LETTER OF TRANSMITTAL

PROJECT: Kelloqq West Square
Drainage and Utility Plan
PROJECT NO: 94024 DATE: 5/27/94

KELLOGG WEST SQUARE
**DRAINAGE, GRADING,
AND UTILITY PLAN**

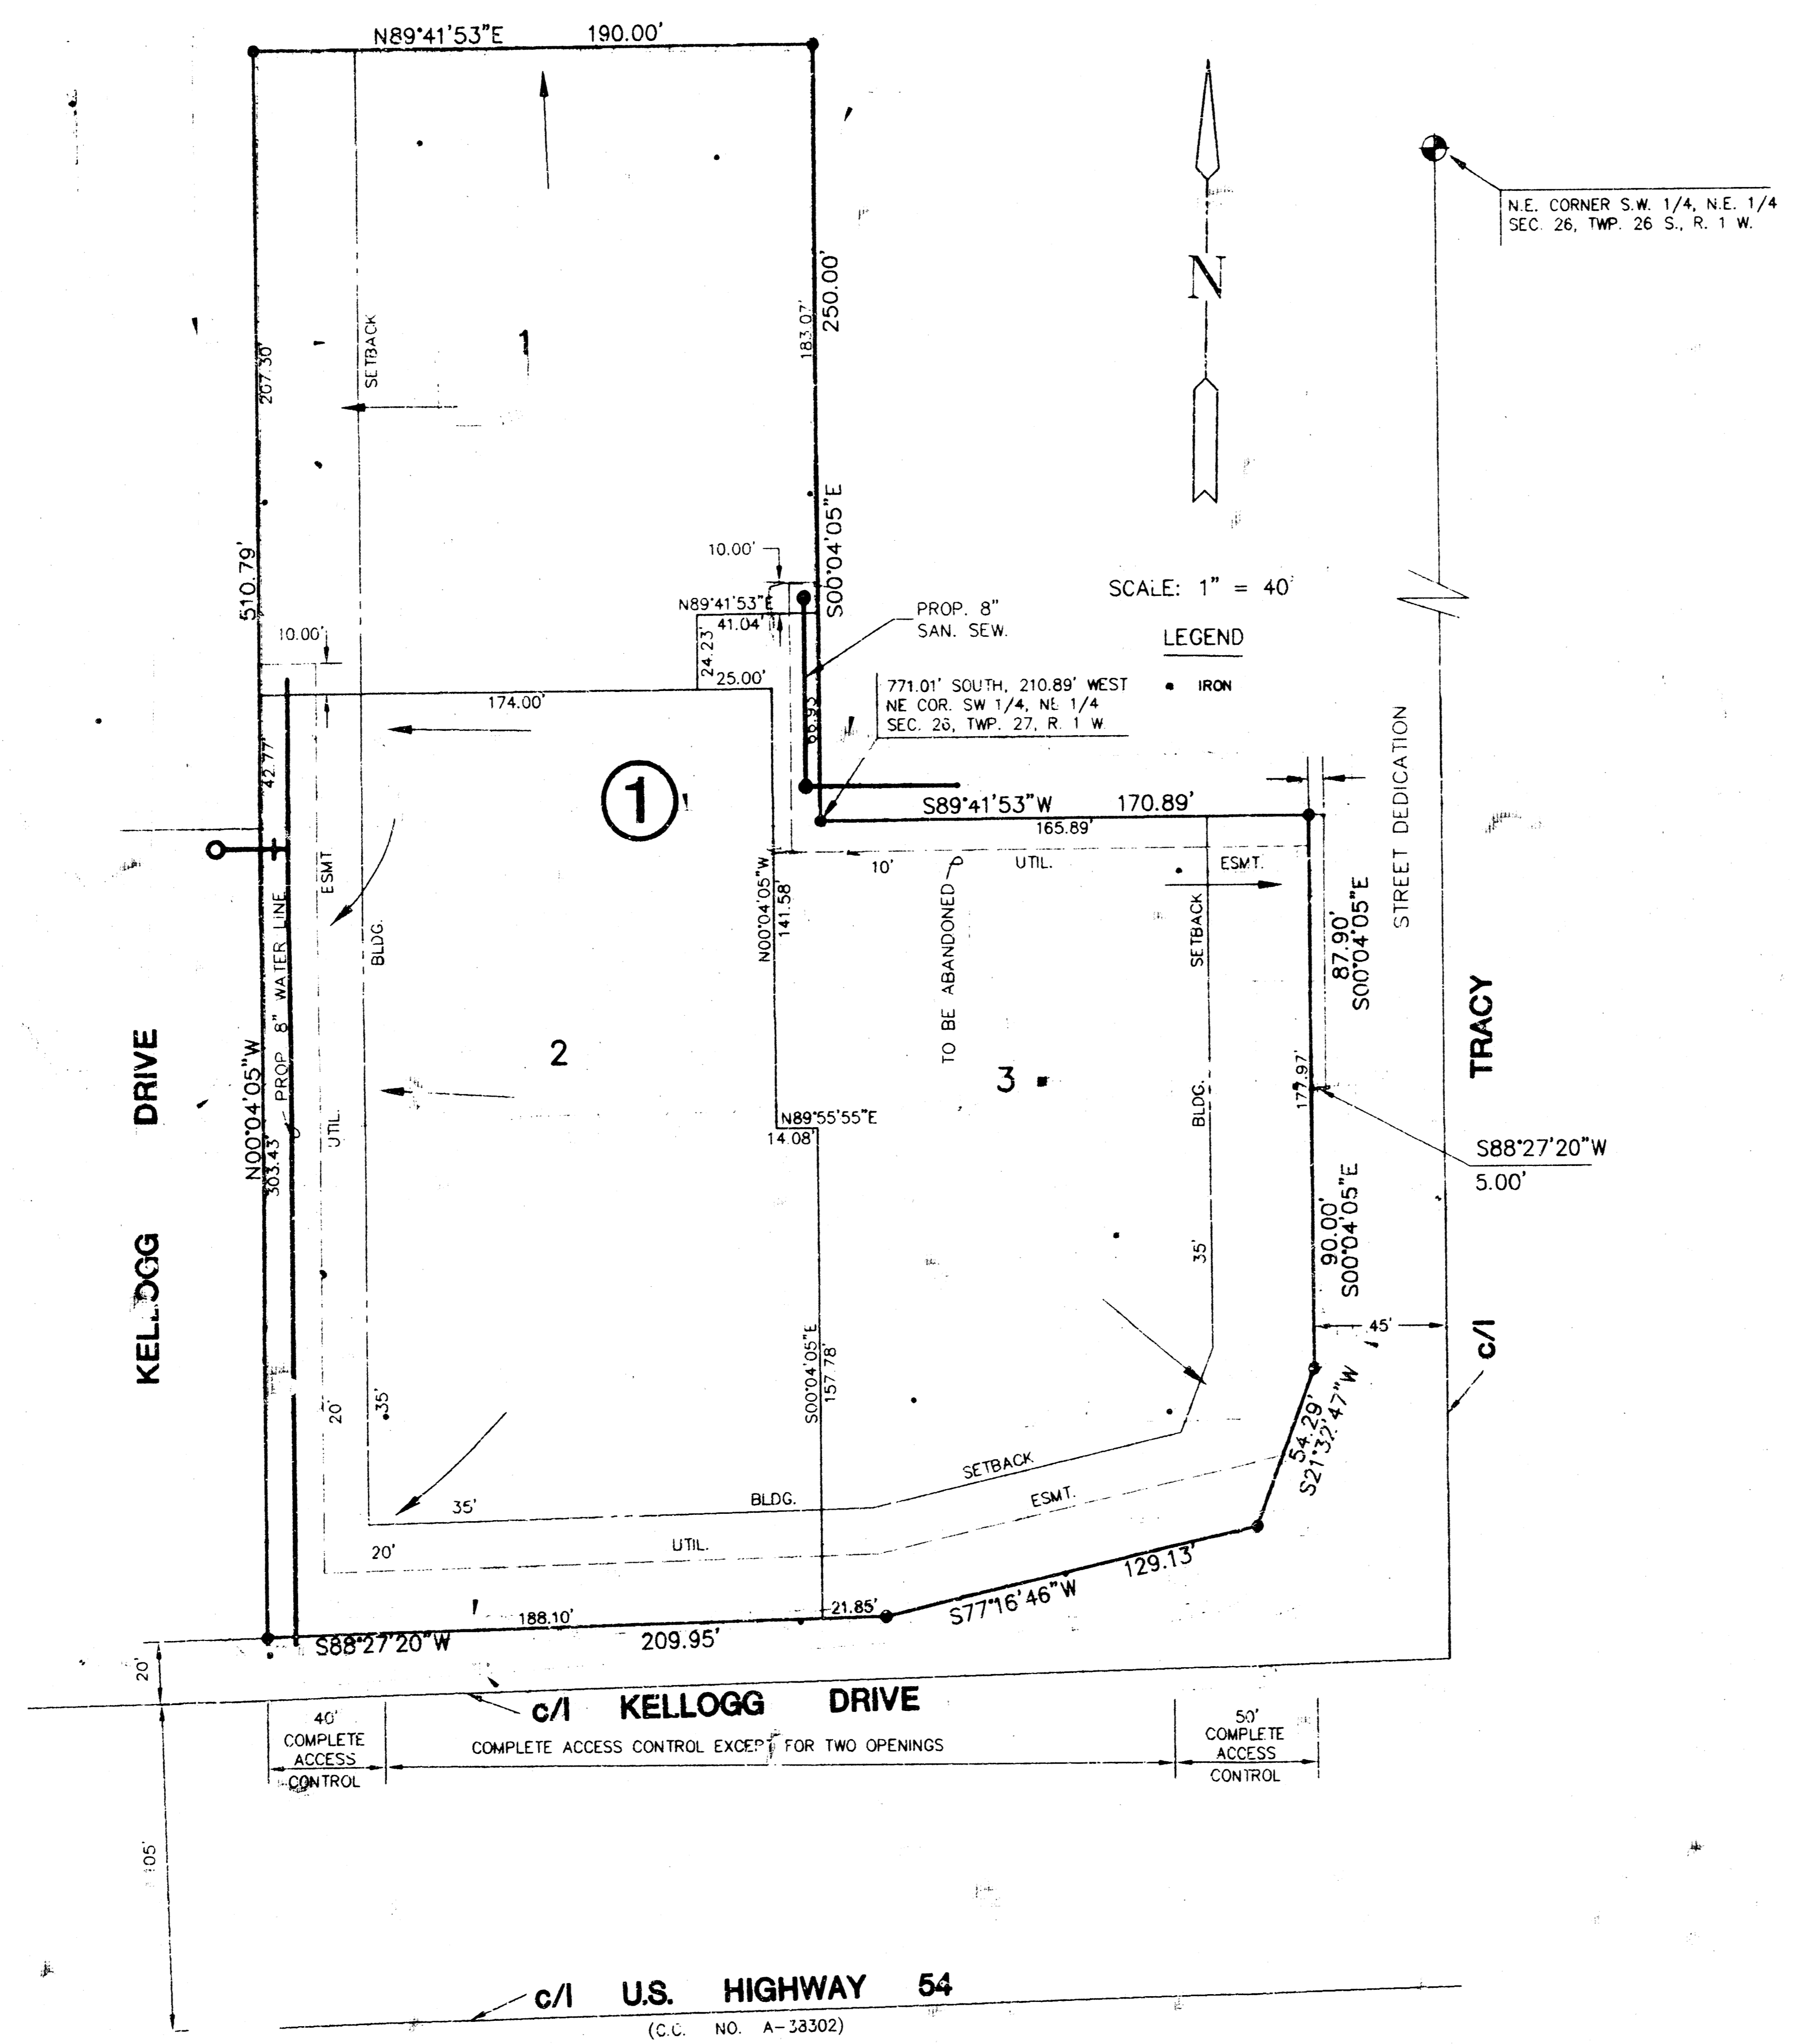
Requires off-site drainage agreement
